**Project #16-005
SA Ferrous Industries
Located near the southeast corner of
200 North and 1900 West, TIN #05-060-0011**

Project Name: SA Ferrous Industries
Proponent / Owner: Alex Bearson / SA Ferrous Industries LLC
Project Address: Southeast corner of 200 North and 1900 West
Request: Conditional Use, Design Review
Current Zoning: Industrial Park (IP)
Type of Action: Quasi-Judicial
Hearing Date: January 14, 2016
Submitted By: Amber Reeder, Planner II

Staff recommends that the Planning Commission **conditionally approve** a Conditional Use Permit and Design Review Permit for Project #16-005, SA Ferrous Industries, in Industrial Park (IP) zone located at approximately 200 North 1900 West, TIN #05-060-0011.

A SITE PLAN
SCALE: 1" = 40'

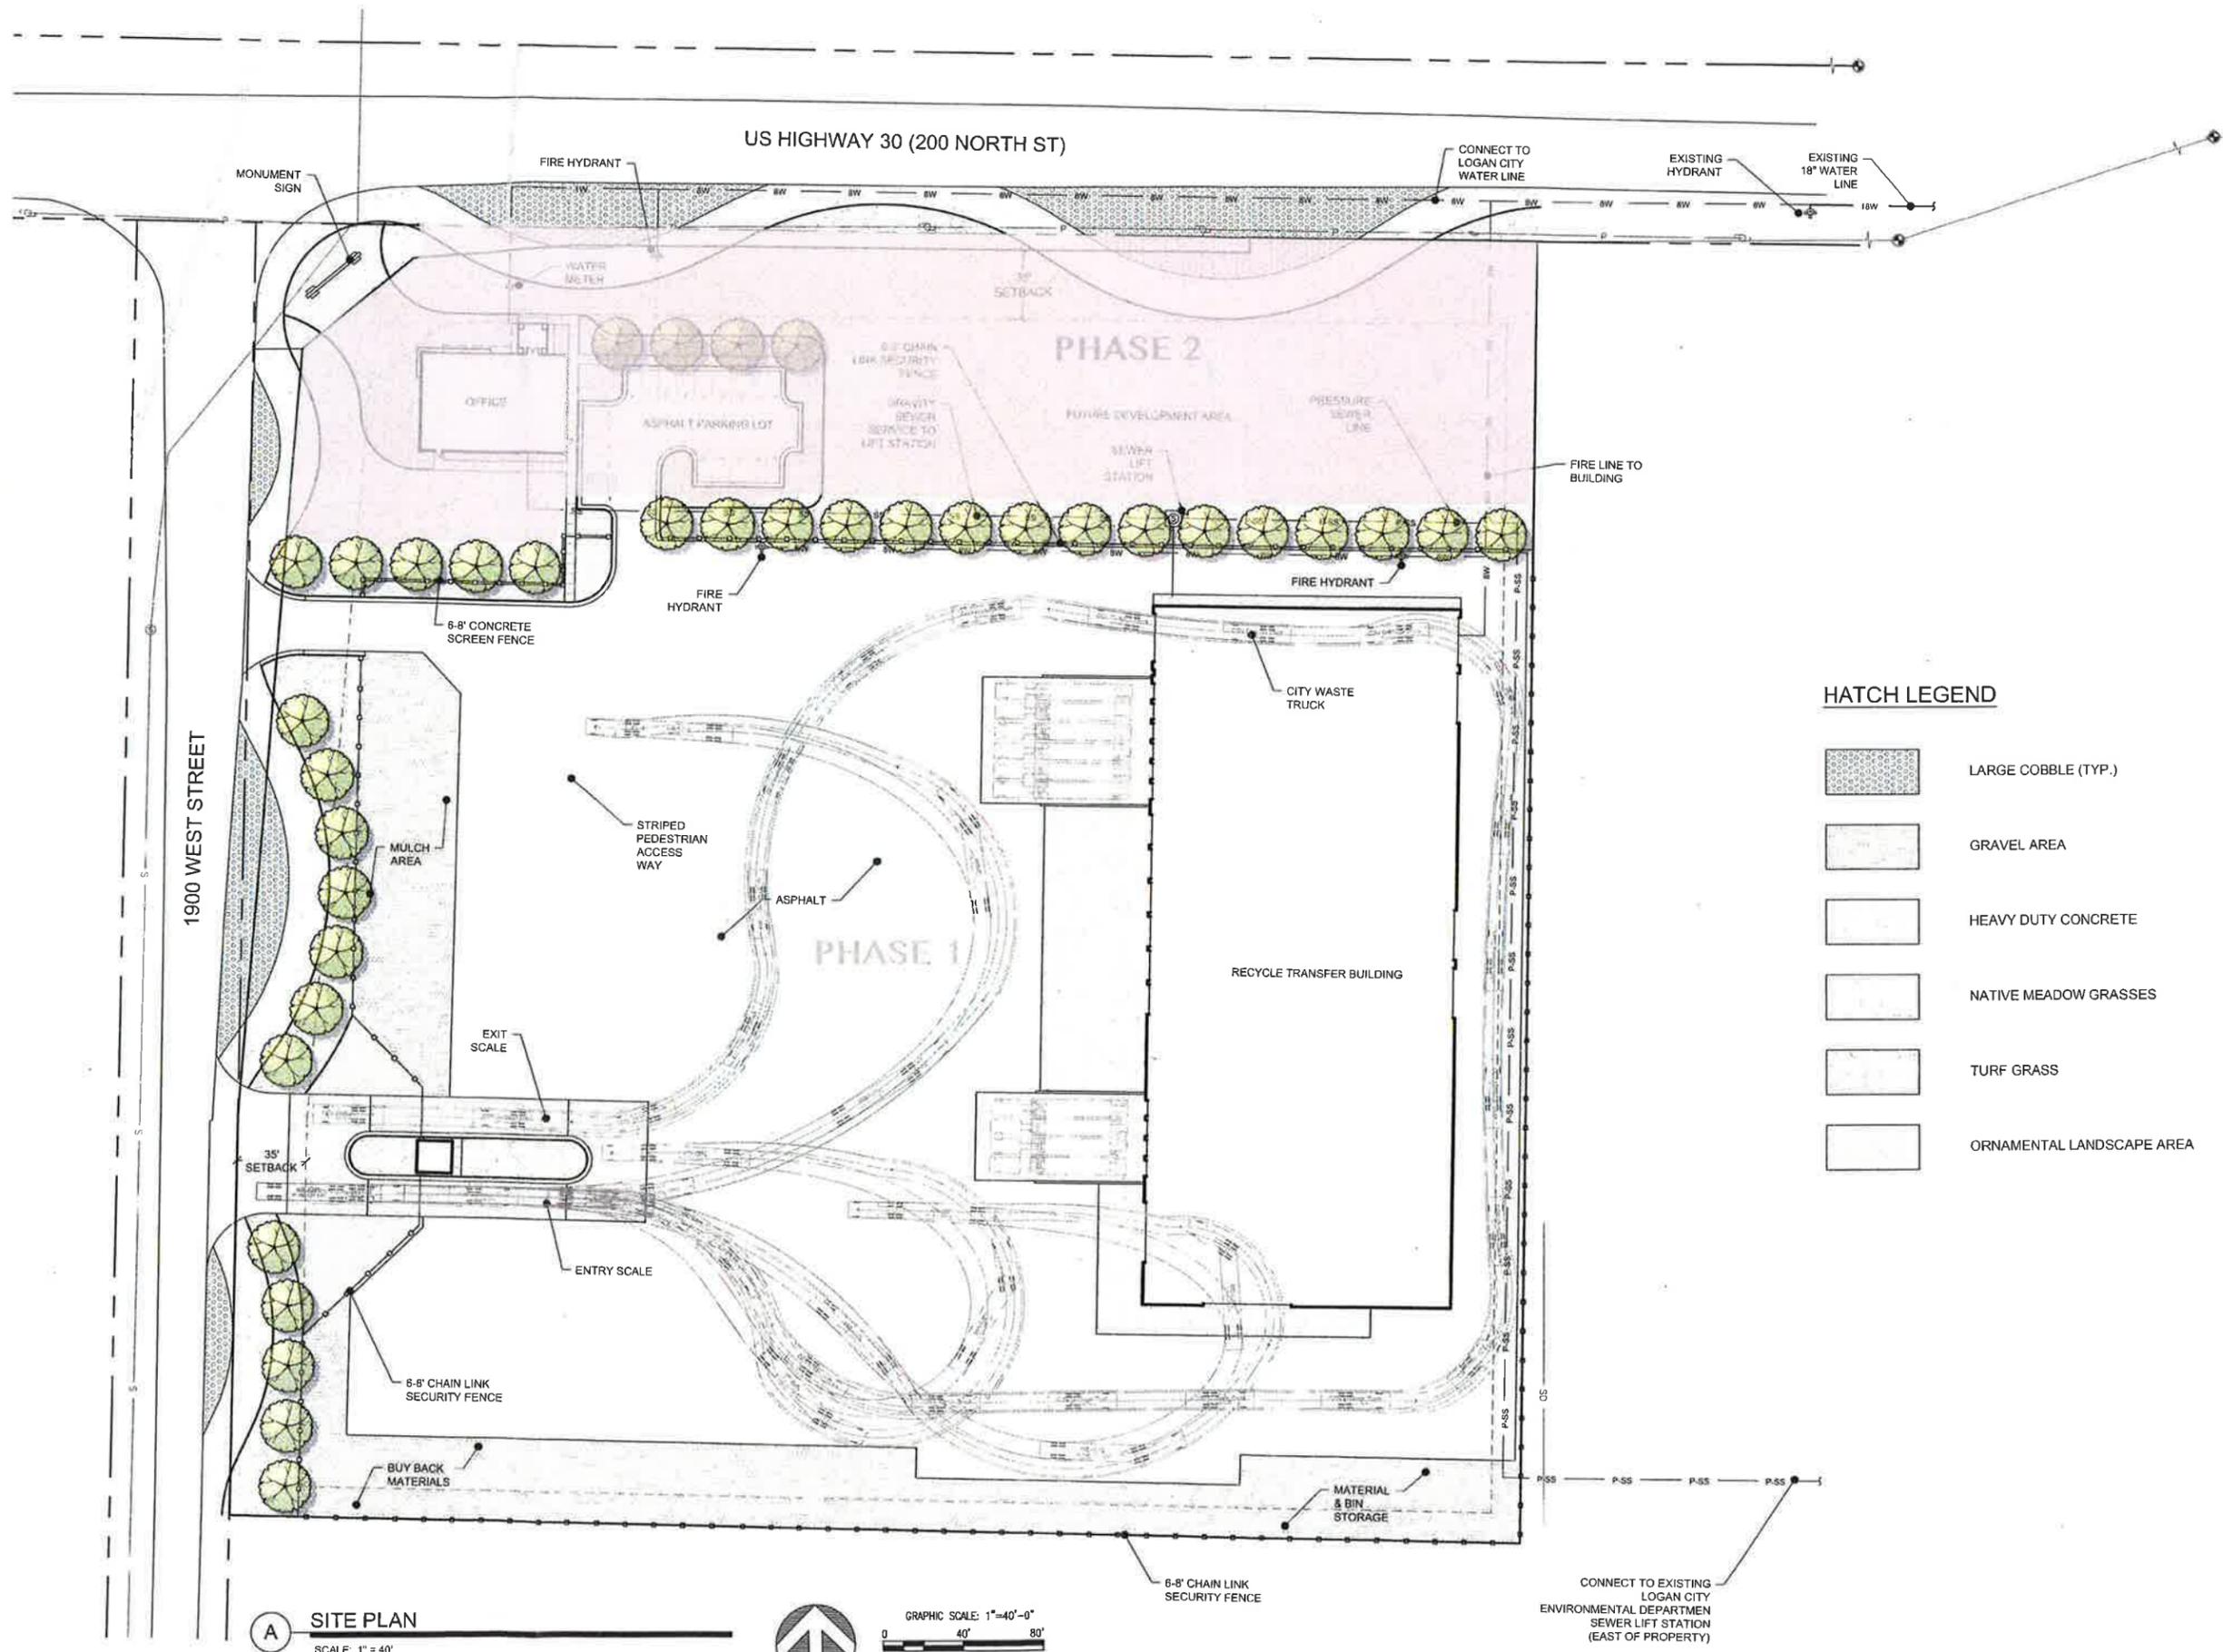
The majority of the site consists of the recycling transfer area. The area is just over 6 acres and is paved in asphalt or concrete and is surrounded by 6-8' tall fencing. The fenced area is setback 150' from the property line on 200 North, approximately 30-40' on the 1900 West property line, and is on the property line on the south and west boundaries of the property. The recycling transfer area has graveled areas for bins for outside storage and a 45,000 sq ft warehouse building with ten (10) semi-truck bays.

There is an outside storage area indicated along 1900 West for mulch. The bin storage and buy-back areas are behind the transfer building and on the south end of the property that borders the landfill. The location is screened with fencing and a landscaped area further shields view of these areas.

The site has two (2) accesses to 1900 West, separated by 200' of frontage. One driveway is allowed per 300', so two (2) accesses may be permitted as the site is 620' long. The northern access is 200' from the intersection to provide for setback. The access driveway locations are in compliance with IP standards and have been reviewed by Public Works.

Sidewalk and parkstrip is indicated on the frontages. Curb, gutter, and street trees will also be required along rights-of-way to City and UDOT standards. Staff is verifying if this is a requirement of Public Works and UDOT. There is substantial paving on the site to allow for movement between the office and warehouse areas but there is not a pedestrian path delineated. For pedestrian safety on the site, staff recommends that a pedestrian route be delineated, such as through pavement paint, between the buildings on the site. As conditioned this request meets the requirements of the LDC.

Outside storage is indicated within the facility and is enclosed by a 6-8’ fence. The fencing on the south, west, and east boundaries is indicated as chain link. The fencing on the north is indicated as a 6-8’ concrete screen fence. Staff recommends that an 8’ fence be constructed. Fencing along public rights-of-way must be “softened” with landscaping along the entire outside fence line and chain link is prohibited on street frontages. The fencing on the north and east side of the property must be solid as to obscure view of the site through the fence. The use of a durable material such as wood or masonry is encouraged per LDC§17.18.010.D.6. As conditioned, the project is compliant with requirements of the Land Development Code.

- 3) A pedestrian path between buildings on the site shall be delineated.
- 4) Land set asides required per code, a minimum of 10% of the site (40,816 sq ft) to be open space and a minimum of 10% of the site (40,816 sq ft) to be in useable outdoor space.

- 7) The north and west elevations of the office building shall provide for 30% transparency (window fenestration) in their design.
- 8) A screening fence is required on the north and west sides of the transfer facility. The fencing must be 8' tall, be solid and sight-obscuring, have landscaping along the entire fence line, and be constructed of a durable material such as wood or masonry.
